Project: **Multi-Family Residential Development**  
South of Via Canon and Camino Capistrano  
Dana Point, California

**RESPONSE TO CITY OF DANA POINT  
GEOTECHNICAL REPORT  
REVIEW CHECKLIST  
PROPOSED MULTI-FAMILY  
RESIDENTIAL DEVELOPMENT  
SOUTH OF  
VIA CANON AND CAMINO CAPISTRANO  
DANA POINT, CALIFORNIA**

Subject: **Response to City of Dana Point, Geotechnical Report Review Checklist**  
March 16, 2007, PN 95101-79

Subject: **Response to City of Dana Point, 2<sup>nd</sup> Review of Geotechnical Report**

Revised Figure 3A Geologic Section A-A'	
South of Via Canon and Camino Capistrano Dana Point, California	
05/23/08	10123-02

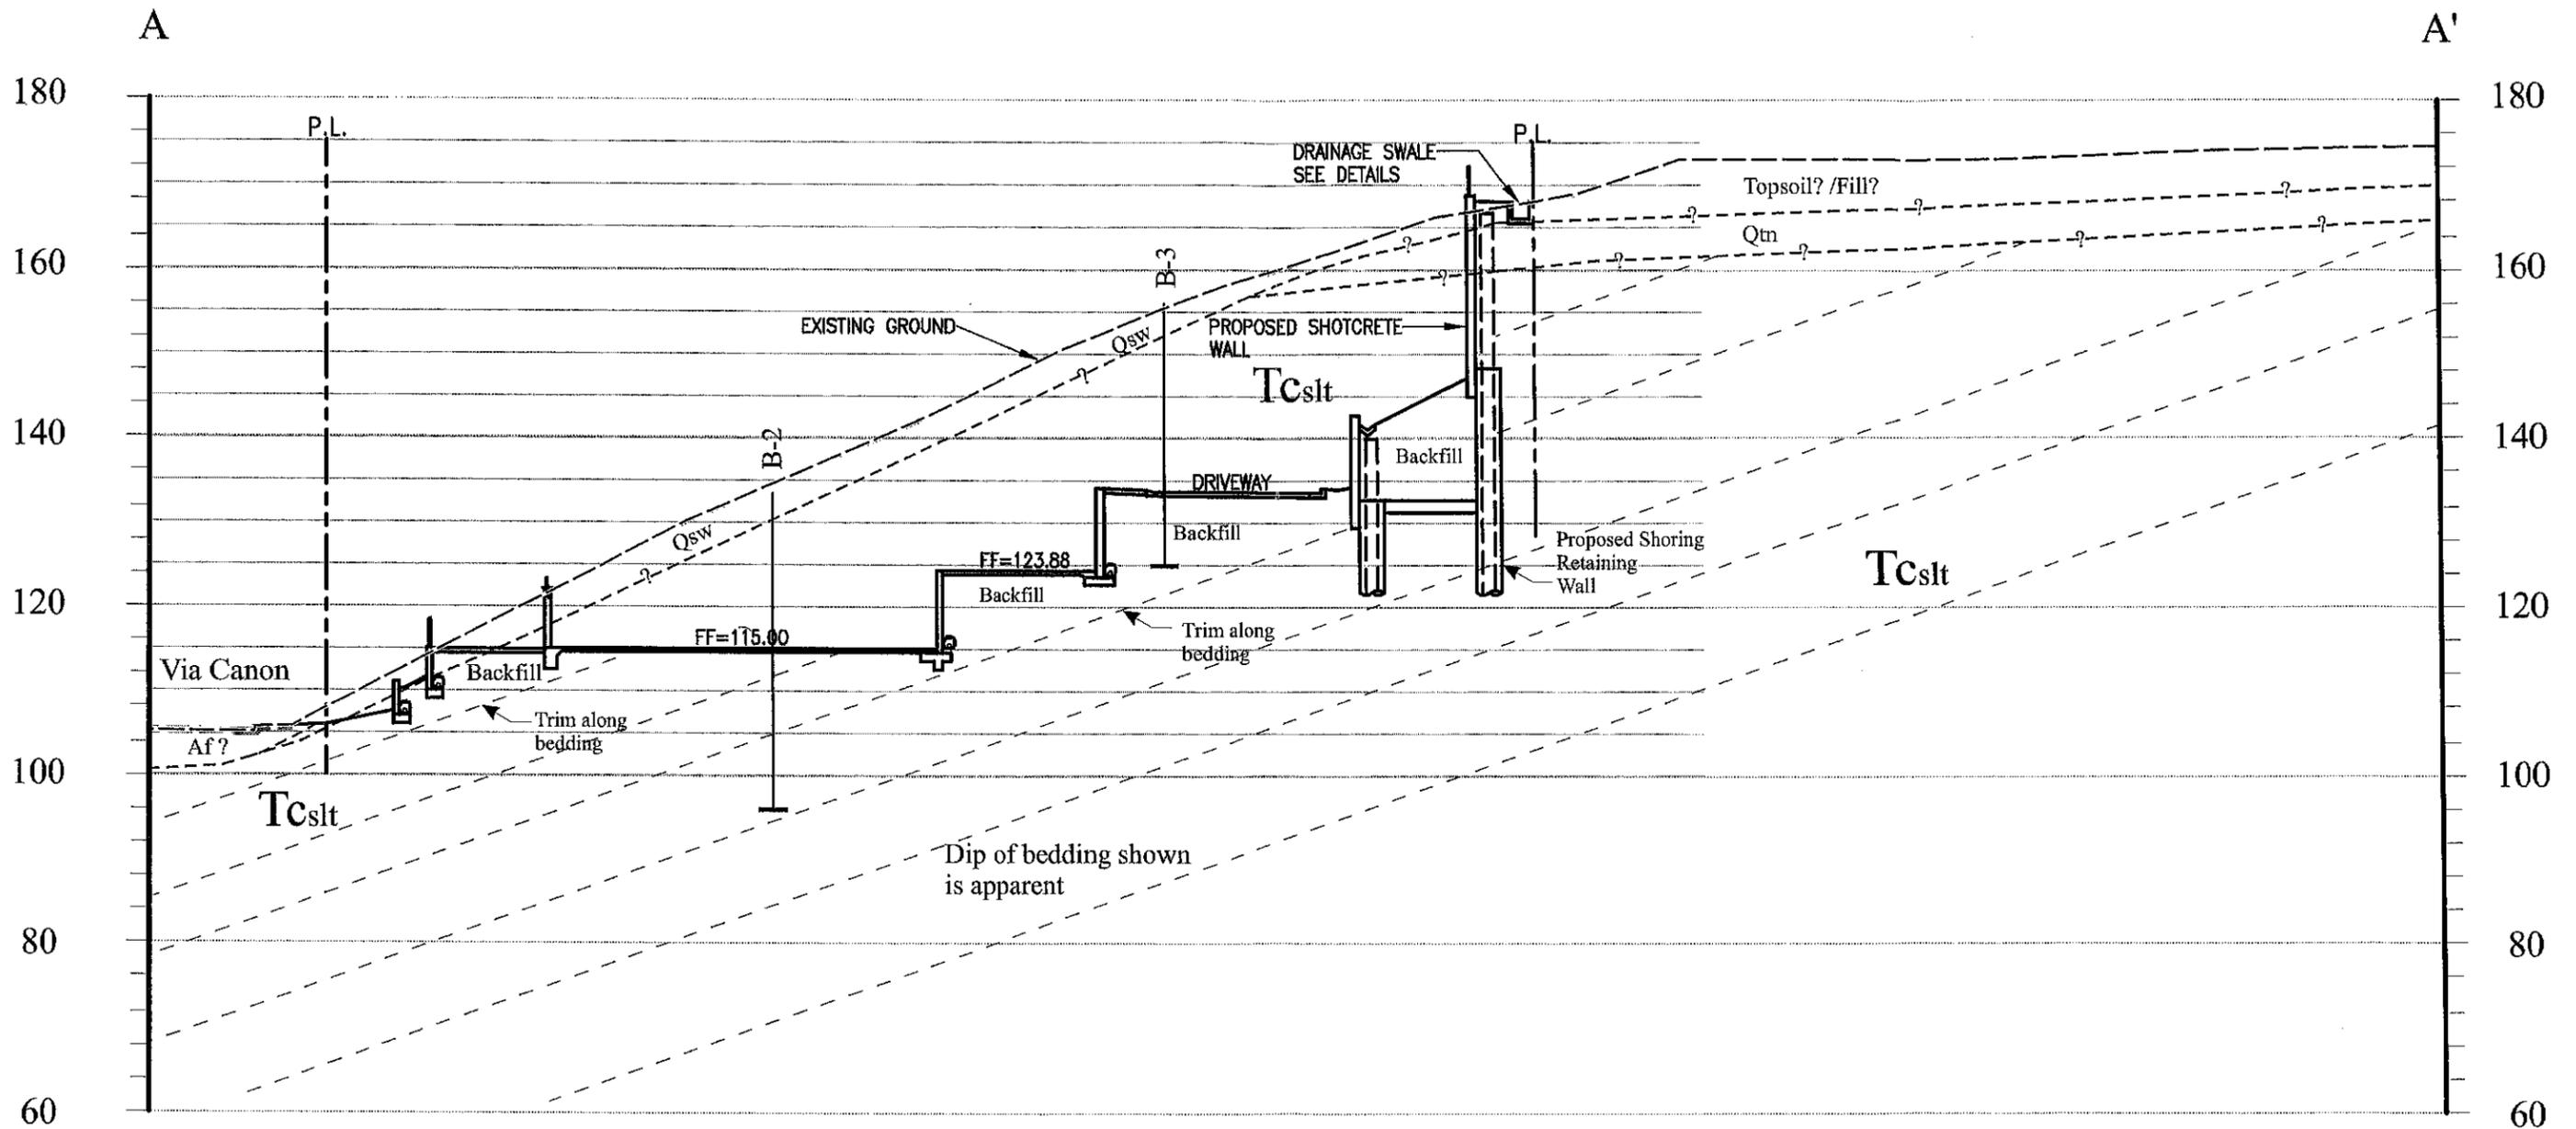
Item # 7 - *Figure 2 does not depict all proposed grading as seen on a preliminary grading plan provided by the city for this review. When ready, please provide a complete grading plan review report with updated cross sections to illustrate proposed site improvements.*

We have incorporated the most recent copy of the grading plan that we received from Toal Engineering into a revised Figure 2, which is attached to this response. Five revised cross-sections showing the elevations of the most recent grading plan are also attached to this response.

Revised Figure 3D Geologic Section D-D'	
South of Via Canon and Camino Capistrano Dana Point, California	
	<b>Earth Systems Southwest</b>
05/23/08	10123-02

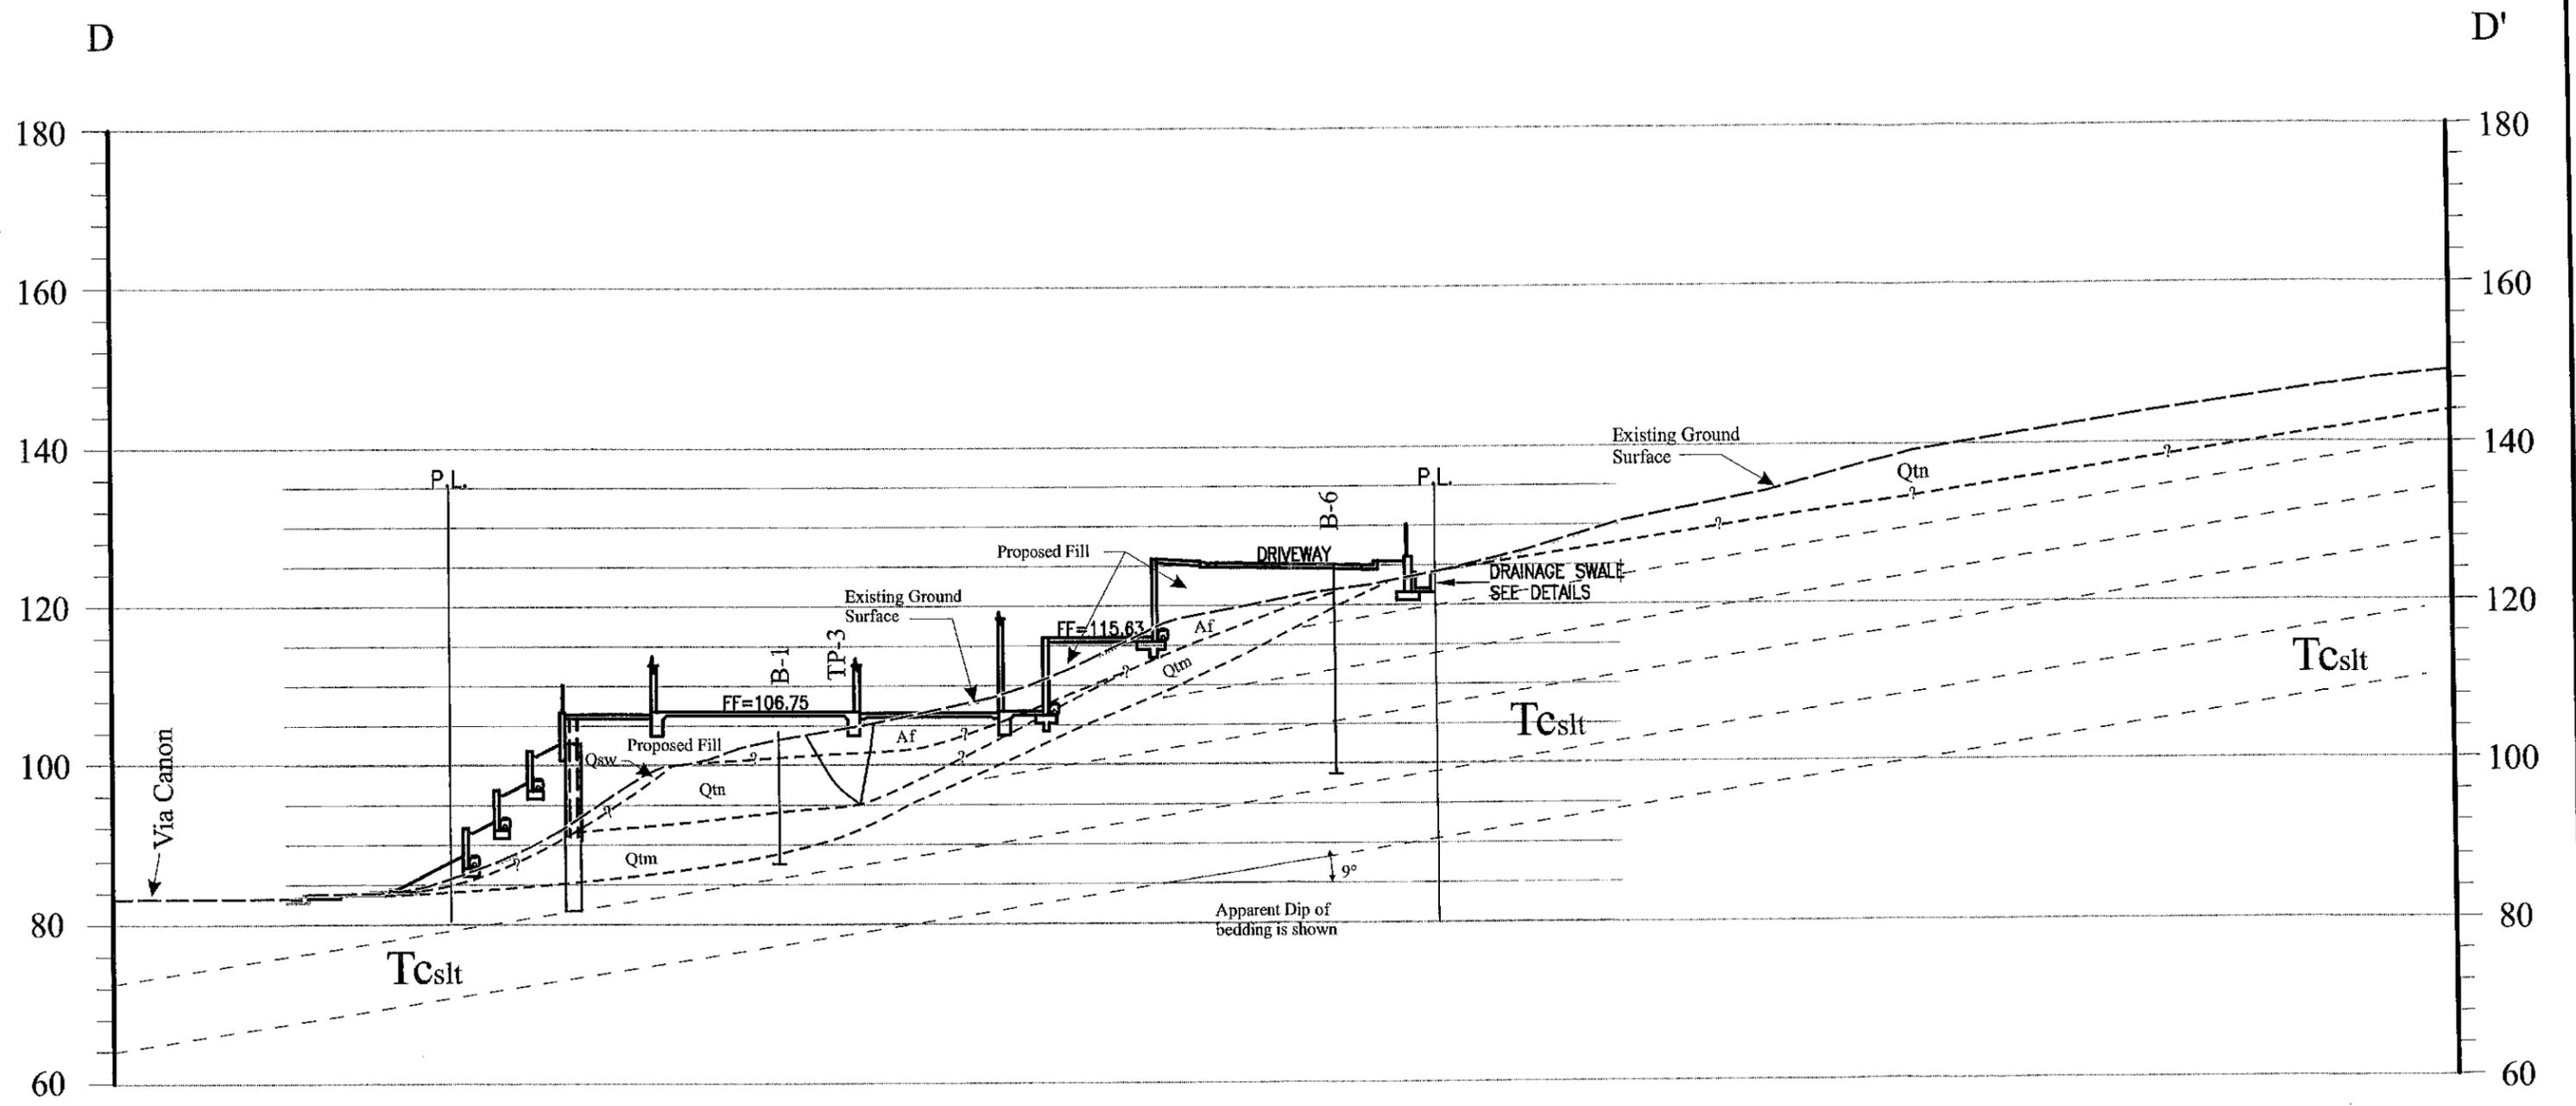
Item # 5 - *Please illustrate the location of the landslide found on published maps for the area. Provide a geologic cross section depicting this feature and the area it is illustrated to affect with regards to the subject site.*

Please see attached revised Figure 2 and the geologic cross section D-D'.
